**Environmental
Planning
Commission**

*Agenda Number: 4
Project #: 2020-003658
SI-2020-00356
Hearing Date: August 13, 2020*

Supplemental Staff Report

Agent	Consensus Planning, Inc.
Applicant	Greystar
Request	1) Major Amendment to Site Plan –EPC
Legal Description	Tracts 1-6 North Andalucia at La Luz Tract 4 North Andalucia at La Luz
Location	SE corner of Coors Blvd. NW and Montano Rd.
Size	Approximately 60 acres
Zoning	PD

Figure 1: Continuous View Plane

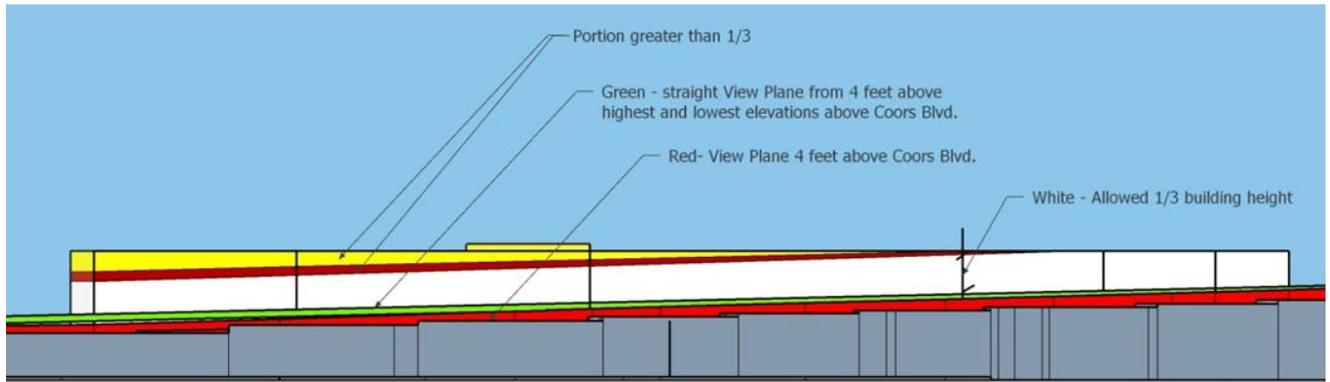
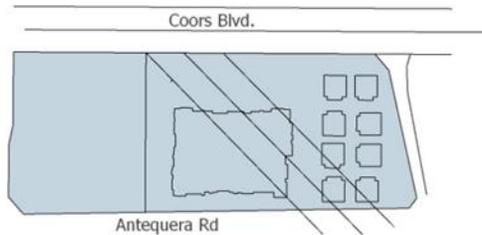
The image above (Figure 1) shows:

Gray = The elevation of Coors Blvd. as it lowers from south to north.

Red = The view plane which is the 4-foot measurement above the elevation Coors in a specific location.

Green = The View Plane as a straight slope from highest to lowest elevation. Extending that plane horizontally at multiple sight line points.

White = the portion of the building allowed to penetrate the view plan (1/3 of the building height.)

Yellow: The portion of the building that penetrates the View Plane and is not allowed, per the Green View Plane.

Orange: Additional portion of the building that penetrates the View Plane and is not allowed, per the Red View Plane.

Figure 2: Various View Planes diagonal to Coors Blvd.

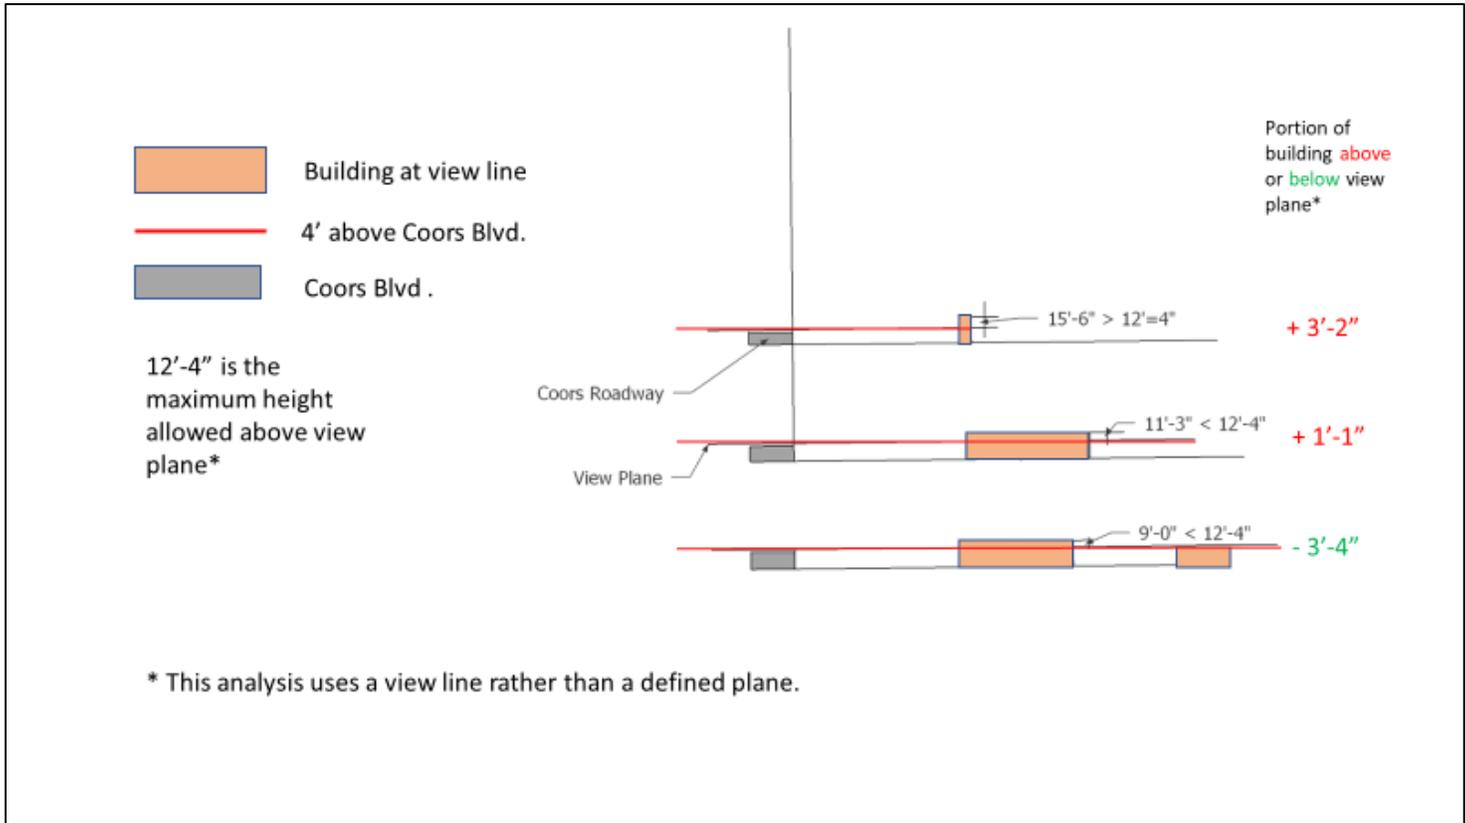
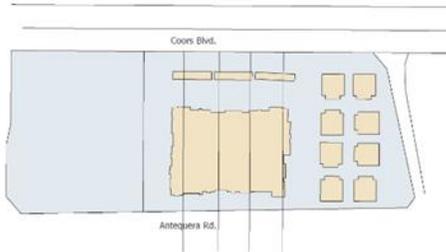
Planning staff evaluated the main building using various elevations as the starting point along Coors. The structure height penetrates the View Plane more than the 1/3 of building height allowed in multiple locations toward the northern property line. (See Figure 2).

View Plane cross-section locations taken from 45-degree angle at various points along Coors Blvd. (see fig. 2 below)

The resulting analysis shows points of disallowed penetration of the View Plane and supports the use of a continuous plane using multiple sight lines as represented in Figure 1. If taken perpendicular to Coors, as the Height, Bulk, Massing diagram from the IDO seems to represent, and the original View Protection language of the Coors Corridor plan clearly stated, the non-compliant height above the view plane becomes more apparent.

Figure 3: View Plane Drawn Perpendicular to Coors

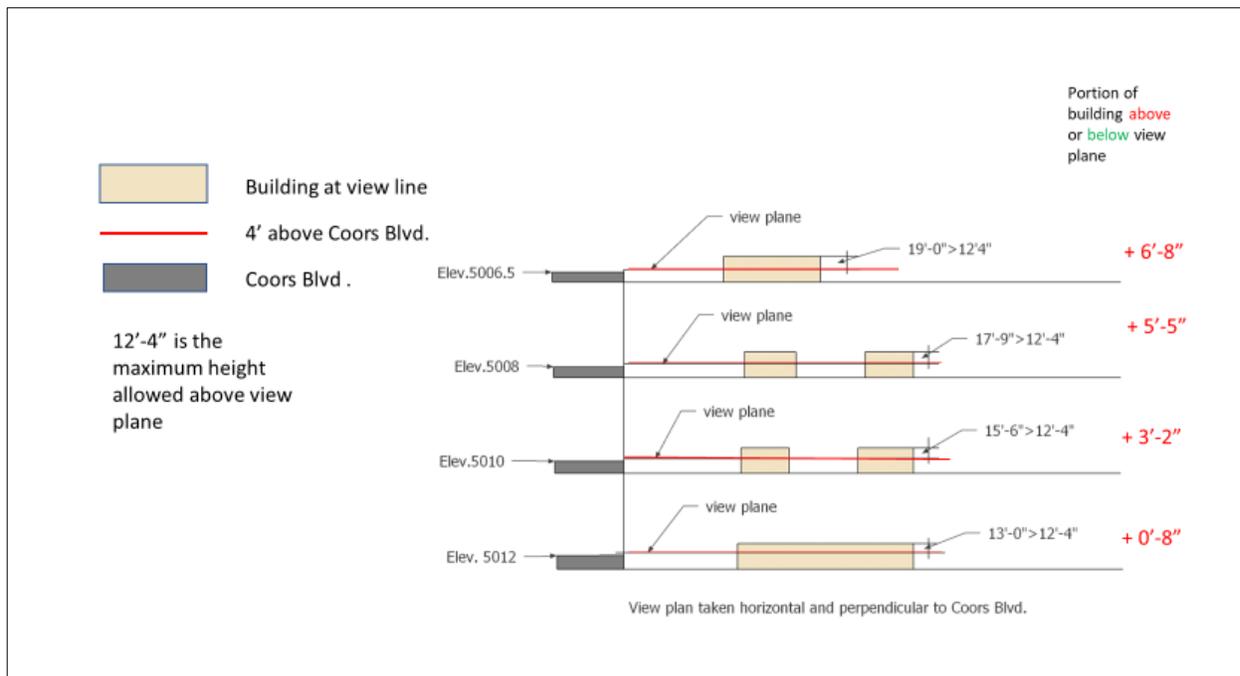
View Plane cross-section locations taken from 90-degree angle at various points along Coors Blvd. (see fig.3 below)

In all methods of analysis, a portion of the main building above the view plane, penetrates more than 1/3 of the total building height, in violation of the required view protection regulations. Revisions would be required to the building design and height to meet the VPO standards.

Figure 4: Applicant's View Frame

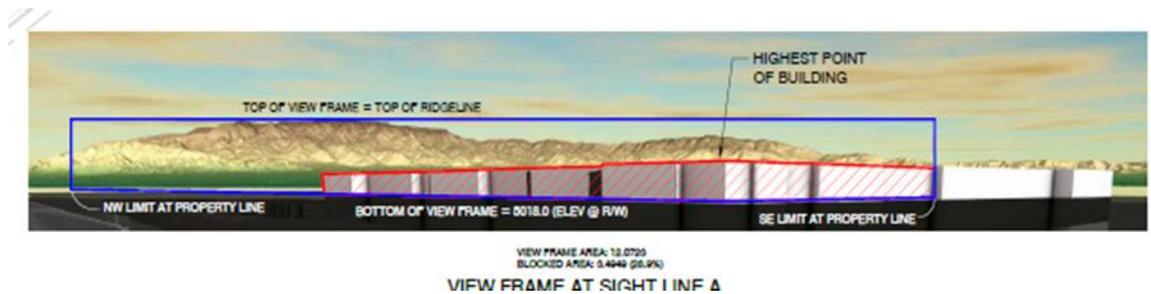
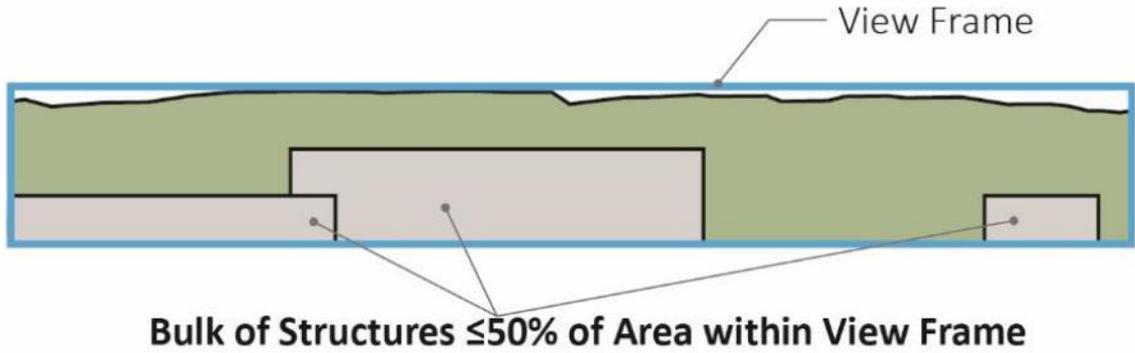
The applicant's View Frame in the above illustration is determined by using a site line that runs from the Coors right-of-way at a 45-degree angle towards the Sandia Mountains and passing through the highest point of the building, thus showing the greatest obstruction caused by the building. That resulting site line location is approximately 70 feet to the south of the site's southern boundary.

The applicant's View Frame is then configured showing all of the building above the elevation of the Coors right-of-way at the beginning of the Sight Line, this being the bottom of the frame, the top of the highest peak of the Sandia's forms the top line of the frame, and the sides representing the property line.

The View Frame should result in a 'slice' of the building mass at one frame location. More are required. The View Frame provided by the applicant (figure 4) shows the building with a tapering roof line as in perspective. This should not be the case. The building height should be at a straight height (figure 5). Although the building does not appear to exceed the 50% Mass/Bulk limitation in this one view frame, the applicant should submit a more accurate drawing of each View Frame to accurately represent bulk and massing.

The Sight Line the applicant used for the View Frame was along a portion of the building with an additional 2-foot parapet wall at the far northeast corner of the largest building. The location of this added parapet height appears to be arbitrary and does not correspond to any rooftop equipment screening, elevator tower, or architectural features. It is located at one of several entrances to the building; however, each of those entrances has a 2-foot parapet at a height of 37', which would be appropriate for this location as well, rather than the 4-foot parapet. This particular parapet wall location, adjacent to the 2-story portion of the building, further brings into question the purpose of this additional parapet height other than to create a single high spot for the sole purpose of benefiting the applicant's view analysis.

This one View Frame provided is based on this small area of additional height. As demonstrated with the View Plane analysis, the building exceeds the acceptable 1/3 view plane penetration. The removal of the 39' height area then requires additional View Frames per IDO section 3-6(D)(3)(a) Sight Lines:

Figure 5: View Frame with straight lines

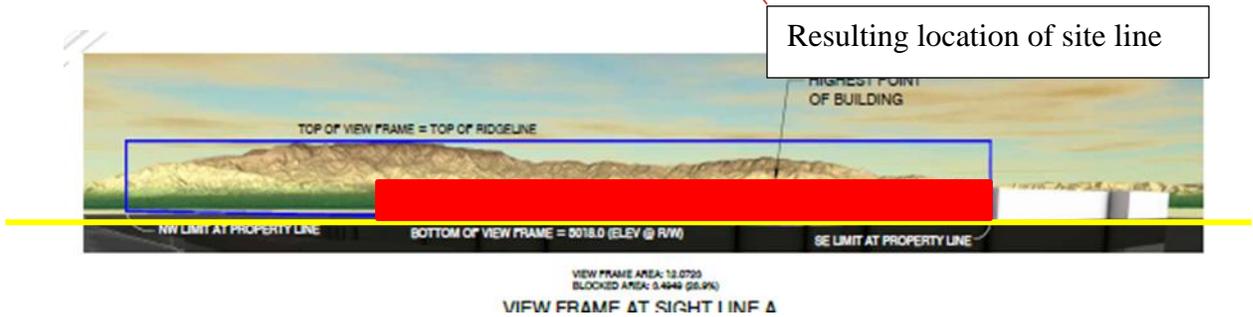
With the removal of the 39' (4-foot high) building parapet at the northeast corner of the building, there are then two areas of highest building height closer to Coors Blvd, and an addition 3 along the south elevation. There should be one View Frame for each high point.

In addition, the Sight Lines should pass through the highest points of all buildings on site. Analysis, as incomplete as it is, has only been provided for one building. No sight line and resulting view frame has been provided for the garages or any of the duplex cottages. A separate sight line for each of the cottages would be unnecessary but there should be one sight line and view frame through the highest point of the building closest to Coors and at the lowest elevation.

Without the additional view frames as required by the VPO-1 regulations, compliance of this project cannot be determined.

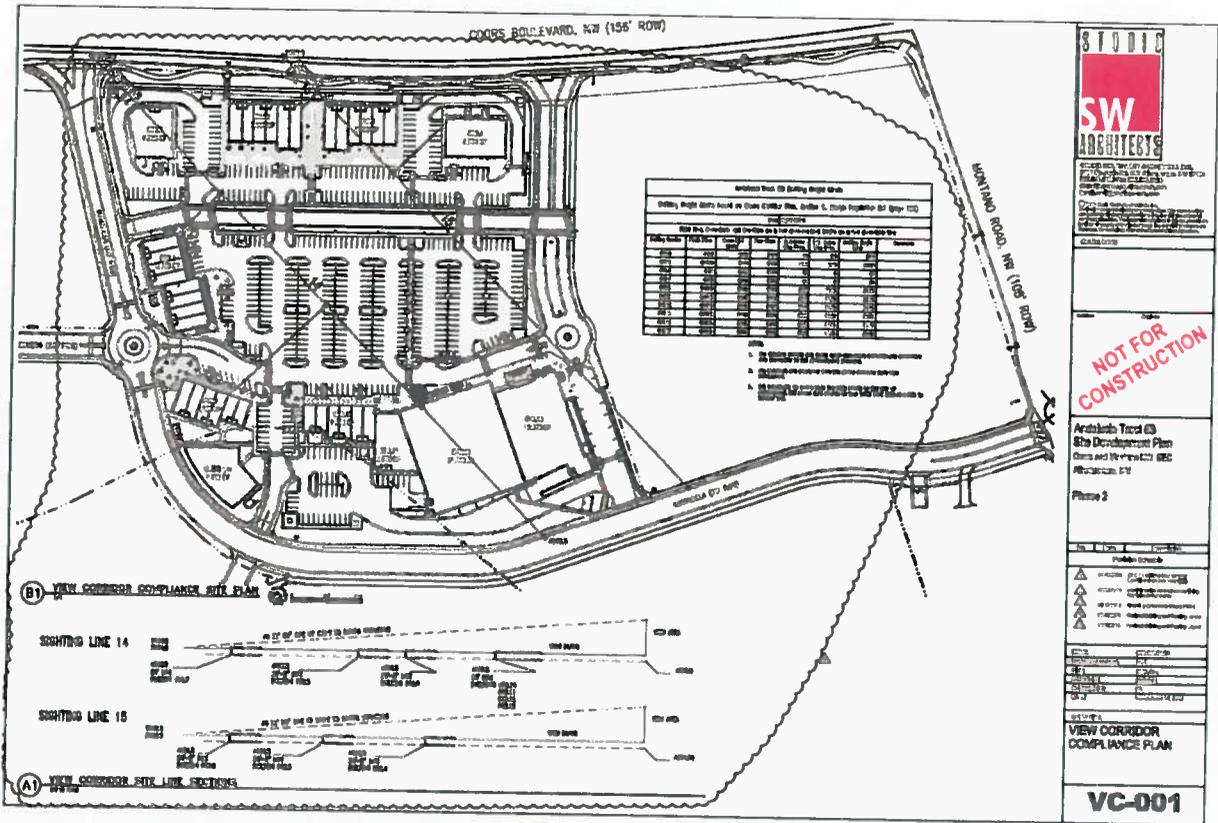
1. Based on the graphic associated with the IDO definition for View Plane, the elevation of the roadway at the southwest corner of the project site.
2. Based on historic practice, the elevation of the roadway at the location of the sight line.

The first of these two options, while different from past practice, was the guidance we initially received from staff and is consistent with the graphic in the IDO. That graphic shows a single 4-foot dimension located at the southwest corner of the example property. This is also consistent with the intent and purpose of the view protection regulations to protect views toward the Rio Grande Bosque and Sandia Mountains, which are generally at a 45-degree angle from the roadway. On a theoretically square property, the most restrictive viewing location for a passenger in a car on Coors would be from this corner looking toward the mountains across the bulk of the property. As people drive farther north, less of the project site and fewer of the proposed buildings are in their view field towards the Sandia Mountains.

When you consider the impact of either an upward or downward slope on Coors Boulevard, the use of the southwest corner of the property to set the view plane makes even more sense. If the slope is increasing from the southern property line as you travel northward, the impact of buildings on your view northeast towards the Sandia Mountains, will increase. If the slope along Coors Boulevard is dropping, then as you travel north, the impact of the buildings becomes less. While the lower elevations at some point along the property frontage may result in a small portion of a building being above the 1/3 height limitation, the intent of the view regulations are still met because the passenger would need to look farther away and south from the Sandia Crest to perceive any negative impacts. Conversely, on sites where the Coors grade is increasing while heading northbound, utilizing the southwest corner for the height is the most restrictive upon the height of buildings on those sites. As stated previously, this is appropriate because those buildings will have a greater impact on the passengers' views across the property towards the mountain.

The proposed Overture at Andalucia project meets the height limitation utilizing this first option as shown in our originally submitted view analysis.

1/3-2/3 Test - Viewpoint 1

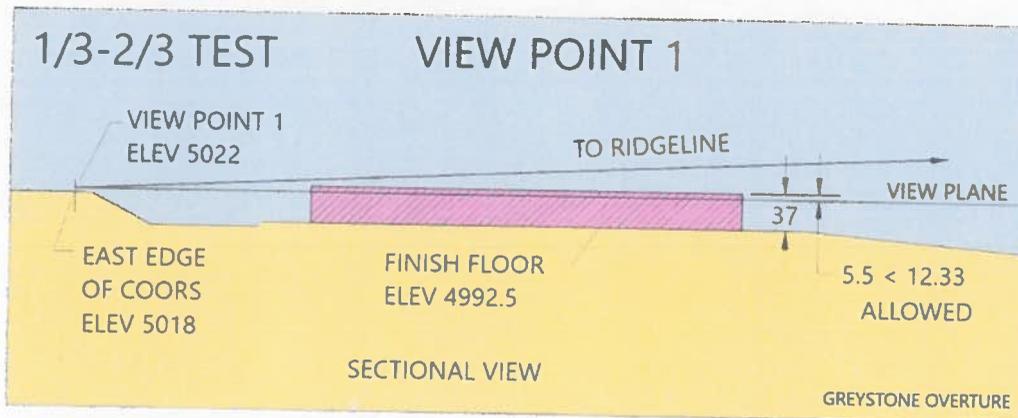
Shown above is the slice or sectional view of the building (purple) along the vertical plane of the first Sightline. Less than 1/3 of the building rises above the view plane, so this view point passes the 1/3-2/3 Test.

1/3-2/3 Test - View Point 2

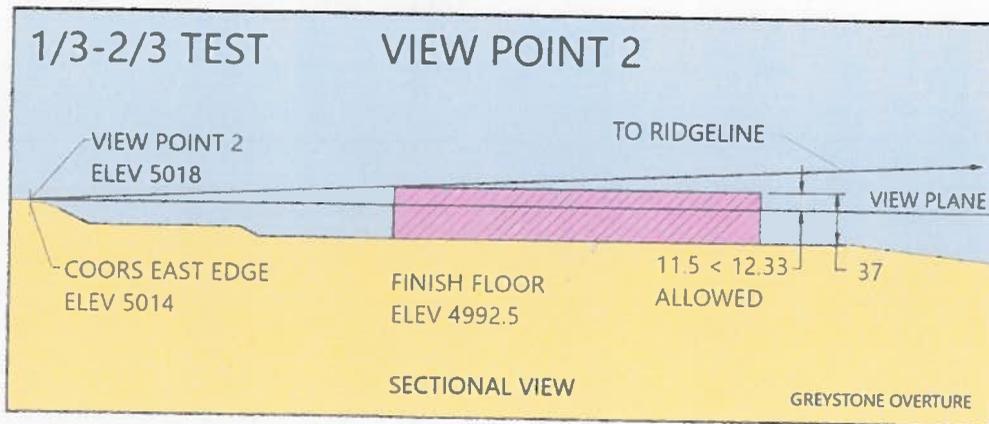
Moving down the road about 100' for the second view point, the results are slightly different. Notice that the sight line going to ridgeline just touches the building, which means that it may rise above the ridgeline in the Ridgeline Test. For the 1/3-2/3 Test of View Point 2, the building rises 11.5' above the view plane. One third of 37' (building height) is 12.33'. So, it passes this test.

1/3-2/3 Test - View Point 3

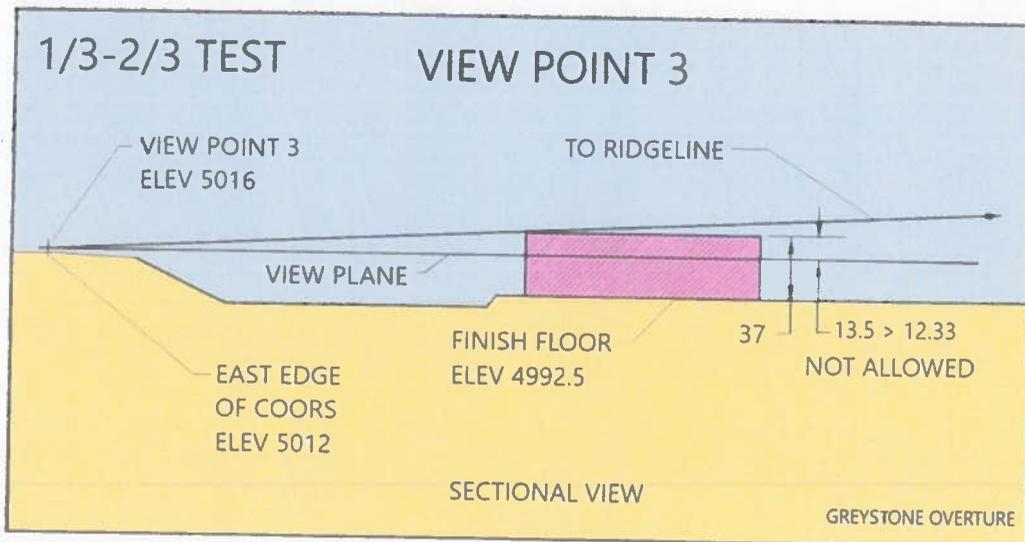
View Point 3 is about 100' north of View Point 2.

Here the top of the building is 13.5' above the view plane. Somewhere between View Point 2 and View Point 3, (about the middle of the west elevation), the building is more than the allowed 12.33' above the view plane.

1/3-2/3 Test - View Point 4

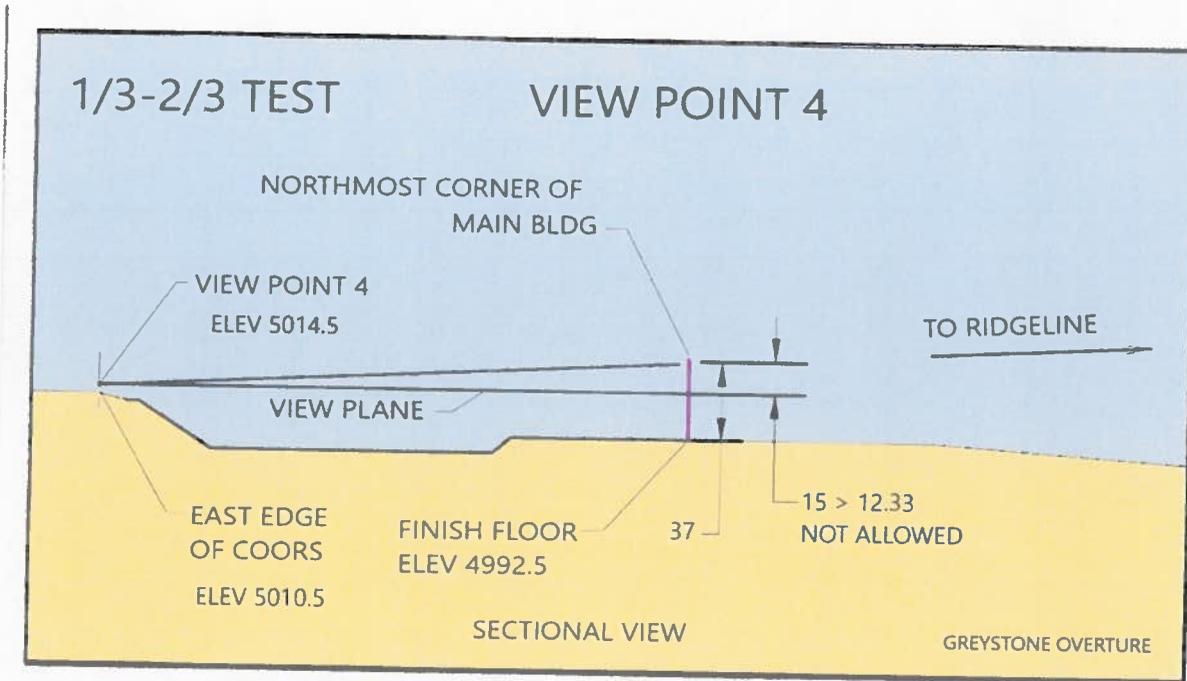
View Point 4 was selected to just catch the northmost corner of the building. This is similar to View Point B in the applicant's supplemental view analysis. The building rises 15' above the view plane or about 2.7' higher than allowed. It also clearly penetrates the ridgeline,

View Point 1

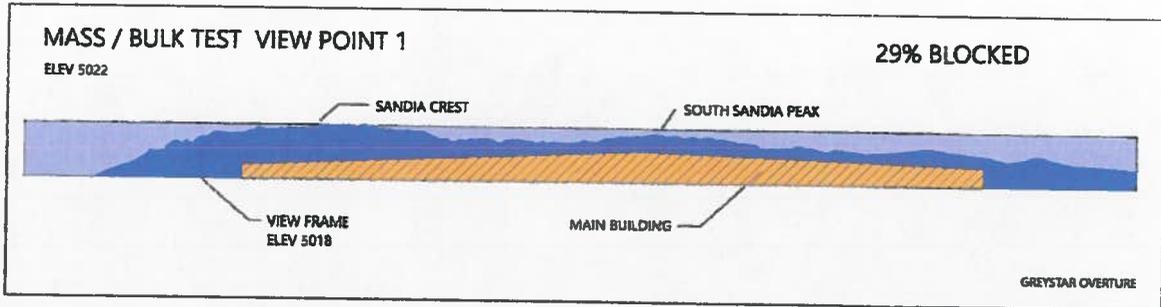
View Point 1 above shows that the building (gold) stays below the ridgeline and consumes only 29% of the view frame. For this view point, the building passes the Mass/Bulk Test and the Ridgeline Test.

View Point 2

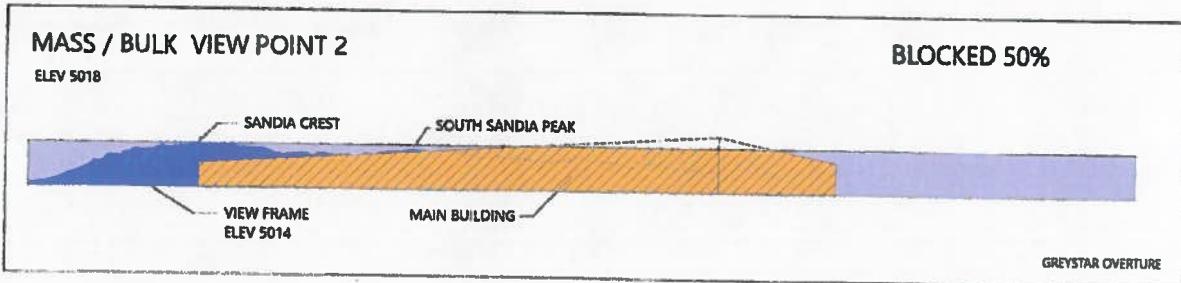
From View Point 2 the building consumes 50% of the view frame which marginally passes. It completely blocks South Sandia Peak and surrounding mountain terrain. It penetrates most of the ridgeline except near the Crest and north.

View Point 3

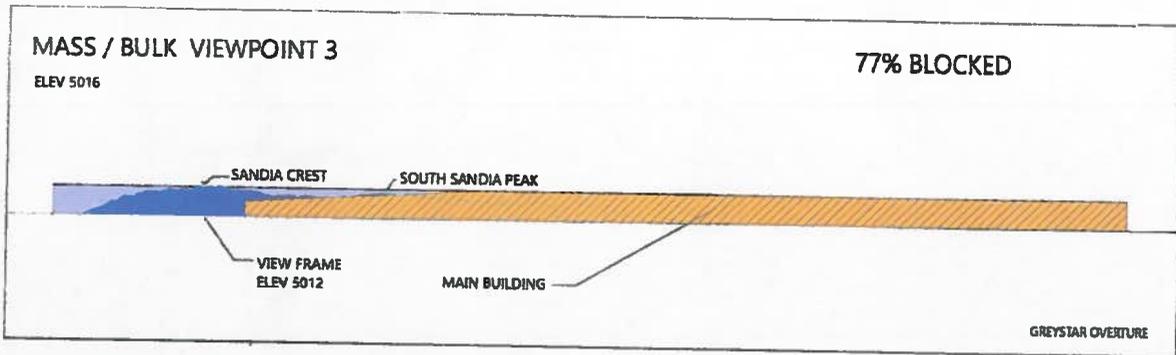
View Point 3 shows the building blocking 77% of the view frame. Predictably, it rises above the ridgeline in all but the left 1/5 of the view frame.

View Point 4

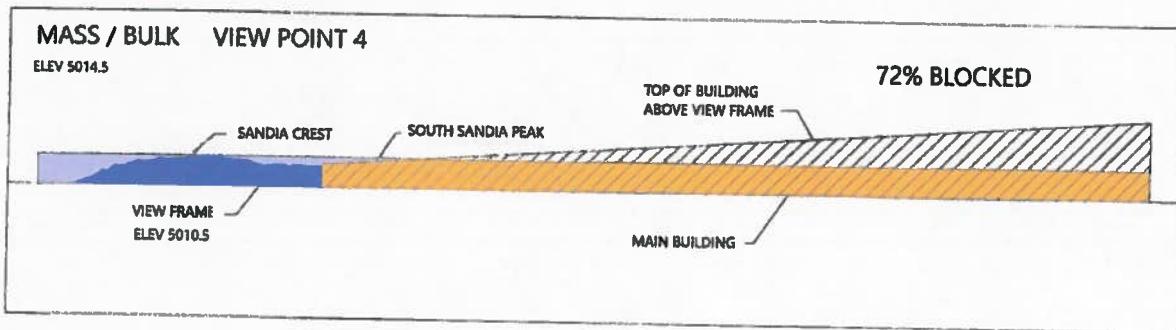
Finally, View Point 4 which coincides with the north end of the building, blocks 72% of the view frame. It also penetrates the ridgeline similar to View Point 3. The top of the building looms large above the view frame.
